Shop Drawing Submittal Review

Project Name: Webster University-**ISB**

Copies	No.	Description
1 PDF	221319P01	(Submittal No.'s)
		(Cannon #22 1319-002) - (Paric #15051-) – (WES #607)
		➢ **Sanitary Specialties Product Data:**
		• Wade Floor Drains: FD-1, FD-2, FD-3
		• Wade Floor Sinks: FS-1, FS-2
		• J.R. Smith Floor Sinl: FS-3
		• Wade Floor Cleanout: FCO-1
		• Wade Wall Cleanout: WCO-1, WCO-2

PROJECT NAME: Webster University ISB
LOCATION: St. Louis Missouri
CLIENT PROJ. NO.: N/A
WES PROJ. NO.: 607
SPEC SECTION: 22 1319 Sanitary Waste Piping Specialties
SUBMITTAL ITEM: See Below -

1100-A Floor Drain with Round Adjustable Top – Perforated Grate

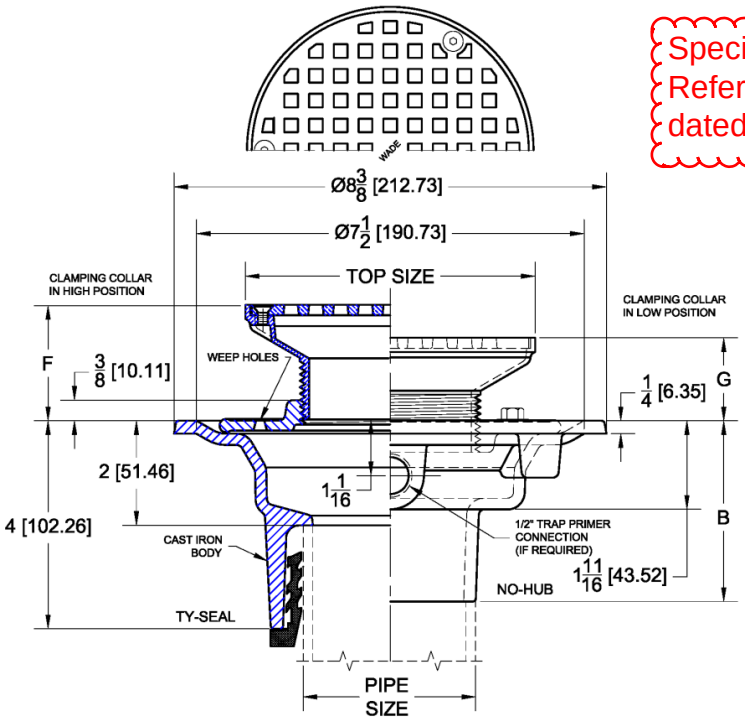
Specified to include trap guard seal device. Refer to drawing P0601, Addendum 2-4, dated 24 May 2016
